# Access Compliance Report

## Public Rights-of-Way

### (Curb Ramps)

Intersection ID: 30337	Main Street: DULIN_CREEK_BV	Cross Street: GOLD_PAN_RD	Location: SE
ADA ID: 4EB357FA9026	Ramp Type: PerpDiag	Initial Pass/Fail: Fail	Overall Compliance: No
		Severity Score: 12.5

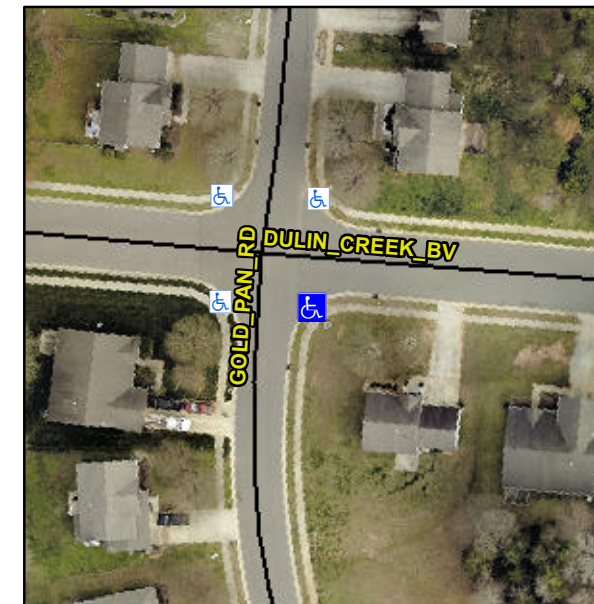
**Not Found, R304.5.3**

Compliance	Description	Data	Compliance	Description	Data
N/A	Ramp Length (in)	39.5	Yes	Ramp Slope (%)	6.0
Yes	Ramp Width (in)	51.5	No	Ramp XSlope (%)	6.8
N/A	Flare Type LT	N/A	N/A	Flare Type RT	N/A
N/A	Flare Slope LT (%)	N/A	N/A	Flare Slope RT (%)	N/A
N/A	Flare Traversable LT?	N/A	N/A	Flare Traversable RT?	N/A
N/A	Landing Length (in)	N/A	N/A	DWS Provided?	N/A
N/A	Landing Width (in)	N/A	N/A	DWS Contrast?	N/A
N/A	Landing Slope (%)	N/A	N/A	DWS Length (in)	N/A
N/A	Landing X Slope (%)	N/A	N/A	DWS Full Width?	N/A
N/A	Landing Curb? (Y/N)	N/A	N/A	DWS Offset (in)	N/A
N/A	Shared Landing?	N/A			
N/A	Gutter Ponding?	N/A	N/A	Gutter Slope (%)	N/A
N/A	Gutter Lip Ht (in)	N/A	N/A	Gutter X Slope (%)	N/A
N/A	Painted X Walk1?	No	N/A	Painted X Walk2?	No
	X Walk 1 Direction	To N		X Walk 2 Direction	To W
N/A	X Walk 1 Width (in)	N/A	N/A	X Walk 2 Width (in)	N/A
	X Walk 1 Slope (%)	1.6		X Walk 2 Slope (%)	0.9
	X Walk 1 X Slope (%)	4.7		X Walk 2 X Slope (%)	2.7

**Remove & Replace Curb Ramp With Two New Directional Ramps or Equivalent.**
